Company	Trenz Electronic GmbH
PCN Number	PCN-20210616
Title	TE0821-01 eMMC Change and Product Update
Subject	BOM change
Issue Date	2021-08-10

PCN-20210616 TE0821-01 eMMC Change and Product Update

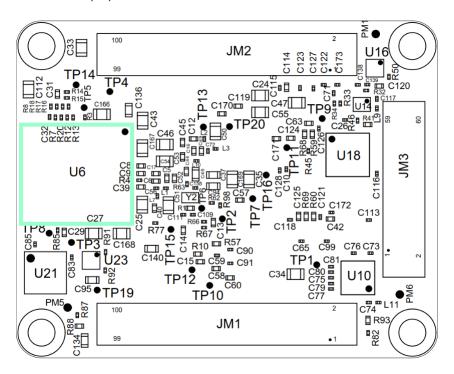
2.4 #4 Set S/N to not fitted

Type: BOM change **Reason:** Part is end of life.

Impact: Track it pad no more available.
